**NC Department of Insurance
Office of the State Fire Marshal - Engineering Division
1202 Mail Service Center, Raleigh, NC 27699-1202
919-661-5880**

Dryer Duct Rated Assembly Membrane Penetrations

Code: 2012 NC Building Code
Section: 716.6.2

Code: 2012 NC Mechanical Code
Section: 504.2 & 607.6.2

**DRYER DUCT DETAIL
SECTION A**

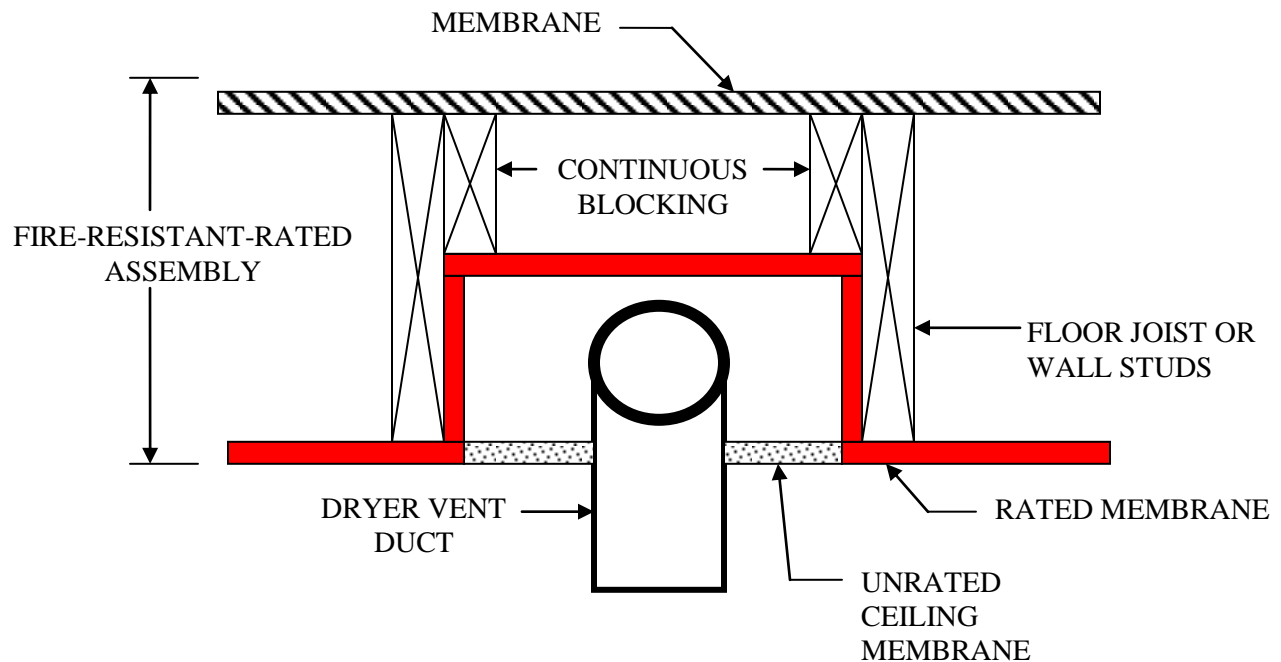
Since Section 504.2 of the NC Mechanical Code prohibits the placement of fire dampers and smoke dampers in dryer ducts, can a dryer duct penetrate the membrane of a rated floor/ceiling, roof/ceiling, or wall assembly?

- 1) The duct can be wrapped with rated duct wrap from the point that the duct enters the rated assembly to the point where it leaves the rated assembly (see Section A). The duct wrap must be listed and labeled for the specific intended use. The duct wrap must be rated the same as the floor/ceiling assembly, roof/ceiling, or wall assembly. The penetration must be sealed to prevent the passage of smoke or flame.
